COR /2014/04060

## **CIRCULAR**

**RE: Changes to Department of Municipal & Intergovernmental Affairs Water, Sewer & Roads Master Specifications**

**Date: June 4, 2014**

DEPARTMENTAL PROJECT SIGN

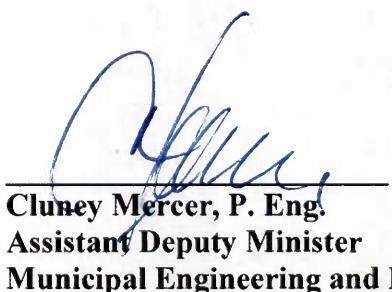
The department's name is changed from *Municipal Affairs* to **Municipal & Intergovernmental Affairs** as shown on the attached drawings.
